TX0-REG-LTR-0030

Subject: **Response to Request for Additional Information Part 2-1 for the TRISO-X Environmental Report and License Application**

Enclosure 1 - RAI Part 2-1 Responses for the TRISO-X Environmental Report and License Application

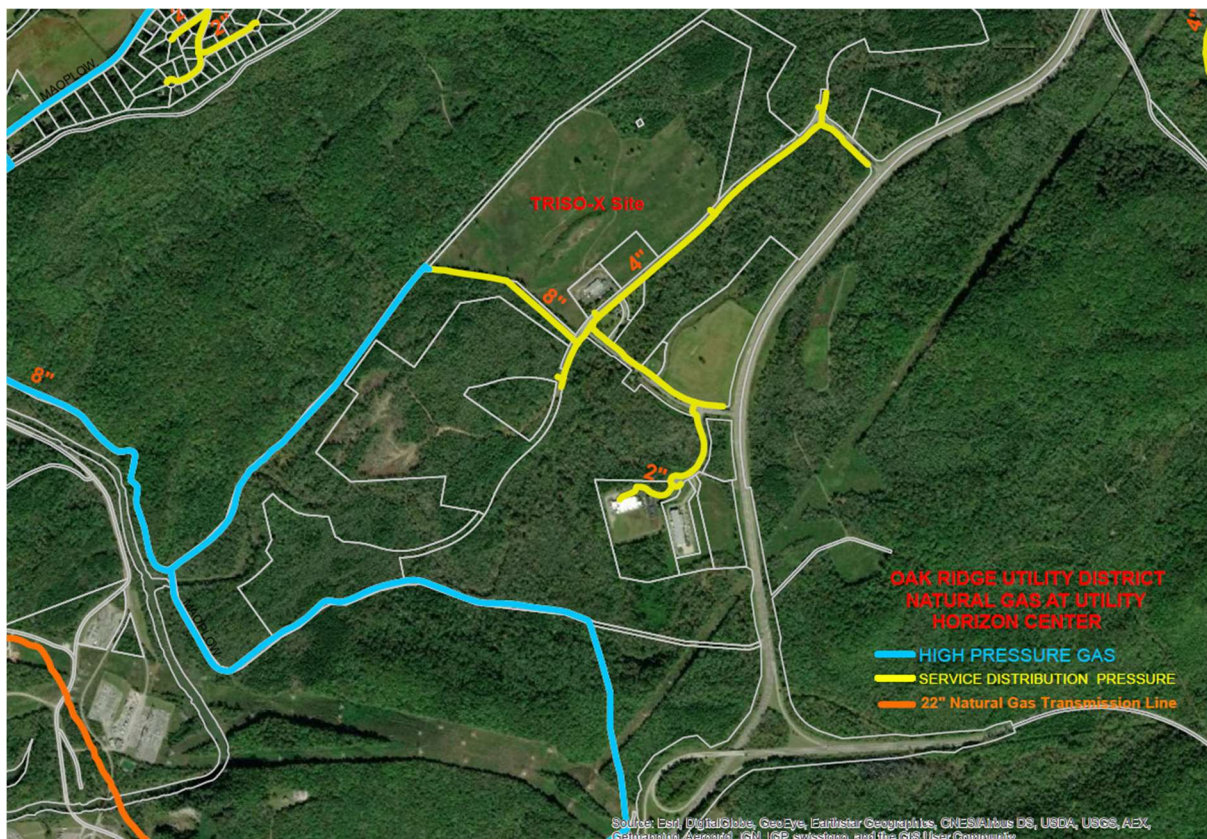
Provide a description of the existing utilities in the vicinity of the FFF site and what would be required to extend them to the site to provide service to the FFF including any potential impacts on the surrounding environment. Additionally, discuss whether hazards associated with natural gas explosions have been assessed for the FFF, including engineered and administrative controls to prevent or mitigate such natural gas hazards.

A 22-inch natural gas transmission line (pipeline ID 3100-1, shown in orange in the figure below) operated by East Tennessee Natural Gas is located approximately 1.25 miles southwest from the nearest corner of the TRISO-X site. TRISO-X assessed hazards from this natural gas transmission line using ALOHA. The ALOHA results indicate that the overpressure from a vapor cloud explosion or the thermal radiation from a jet fire would not damage the TRISO-X facility. Therefore, no engineered or administrative controls are used to prevent or mitigate natural gas hazards.

Natural gas service to the local area is provided by Oak Ridge Utility District. The natural gas service line follows the western border and southern border (along Renovare Blvd) of the TRISO-X site. A natural gas regulator station is located at the northwest corner of the TRISO-X site (see the blue/yellow transition in the figure below). The line upstream of the regulator station is an 8-inch steel line operating at 150 psi (blue line in figure). The line downstream of the regulator station is an 8-inch HDPE line operating at 40 psi (part of yellow line in figure), which transitions to a 4-inch HDPE line at the southwest corner of the site. The 4-inch HDPE line follows Renovare Blvd. Based on these line sizes and pressures, the bounding natural gas service accident scenario is an explosion located upstream of the regulator station from the 8-inch steel line operating at 150 psi. TRISO-X assessed hazards associated with a natural gas explosion using ALOHA. The ALOHA results indicate that the overpressure from a vapor cloud explosion or the thermal radiation from a jet fire would not damage the TRISO-X facility. Therefore, no engineered or administrative controls are used to prevent or mitigate natural gas hazards.

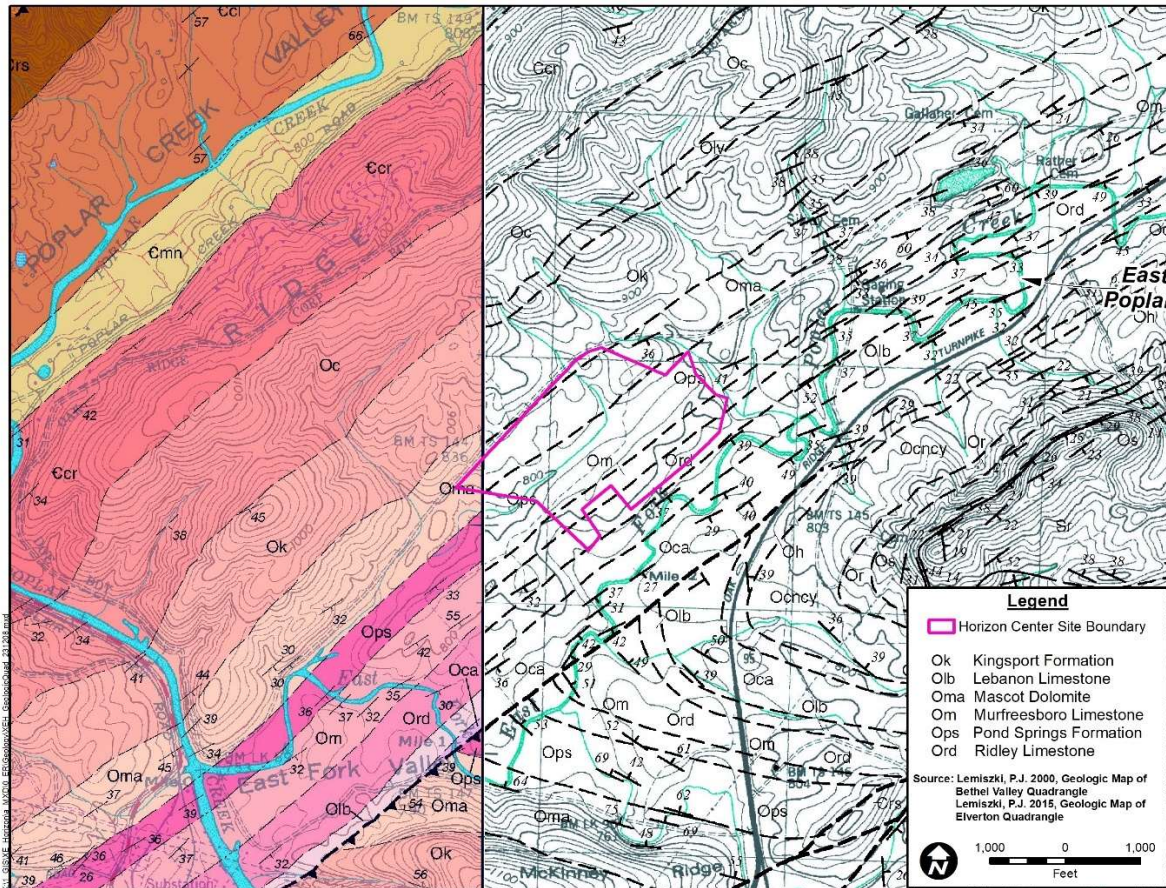
Provide a revised version of figure 3.3.3-1, “Geologic Map in the Vicinity of the Horizon Center Site,” from the ER that includes the geology west of the proposed FFF Site near the west outfall.

ER figure 3.3.3-1, “Geologic Map in the Vicinity of the Horizon Center Site,” does not show the geology on the west side of the proposed FFF Site. Therefore, the Elverton Quadrangle Geology map is not shown. A complete picture of the geology at the FFF Site and vicinity is germane to effectively evaluating stratigraphic and geologic conditions.

ER Figure 3.3.3-1 will be replaced with the new figure below, which includes geology on the west side of the TRISO-X site. Note that the sources of this figure are two separate maps joined together (see the legend), which is why the left side of the figure is in color and the right side of the figure is in grayscale. The colors do not add information to the map, they only provide contrast between formations.

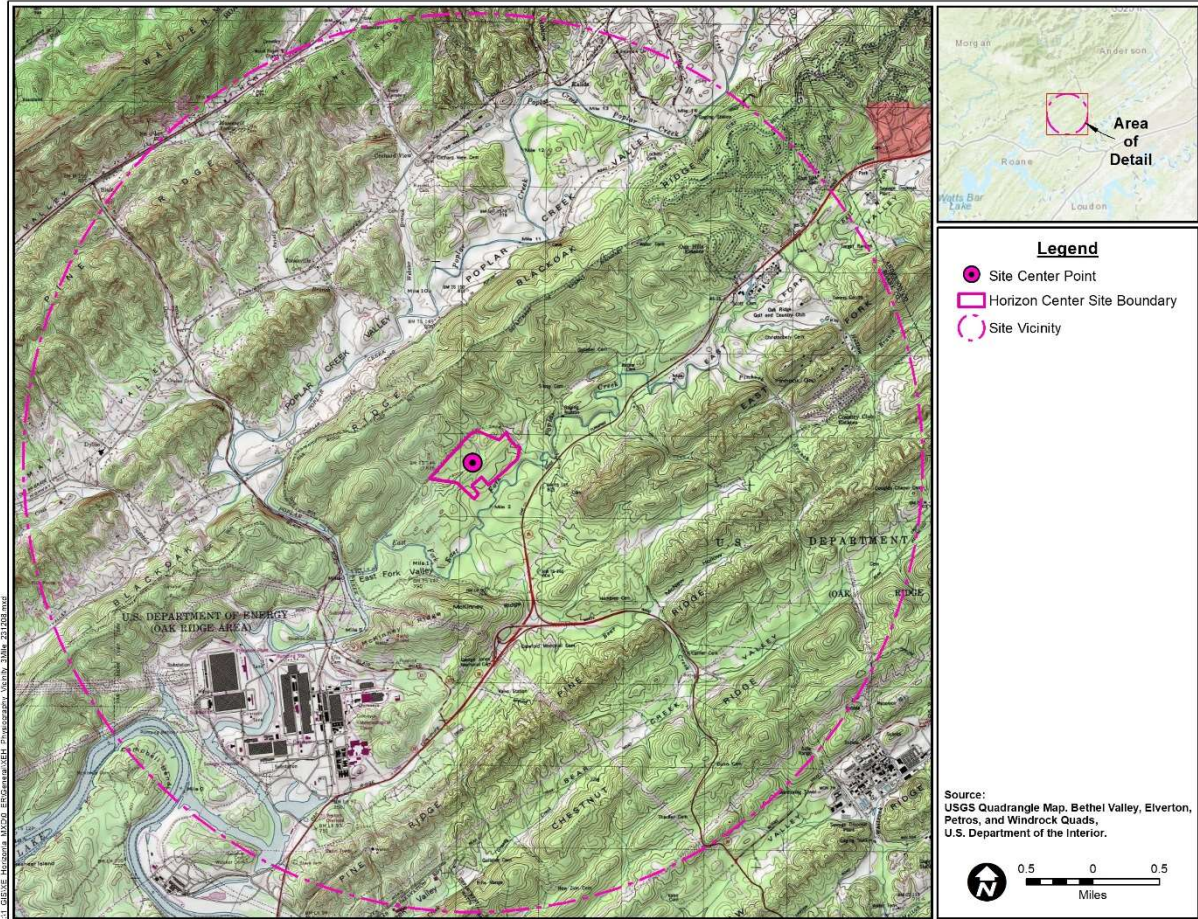
Provide a supplemental figure to figure 3.3.3-2, “Physiography in the Vicinity of the Horizon Center Site,” from the ER that includes the site boundary and current USGS topographic mapping details for the proposed FFF Site and vicinity.

The scale within ER Figure 3.3.3-2, “Physiography in the Vicinity of the Horizon Center Site,” does is not a large enough for the NRC staff to effectively evaluate of pertinent topographic features in and around the site. For example, it is not clear whether USGS topographic mapping is illustrated on the figure.

ER Figure 3.3.3-2 will be replaced with the new figure below which includes a larger scale based on USGS topographic mapping.
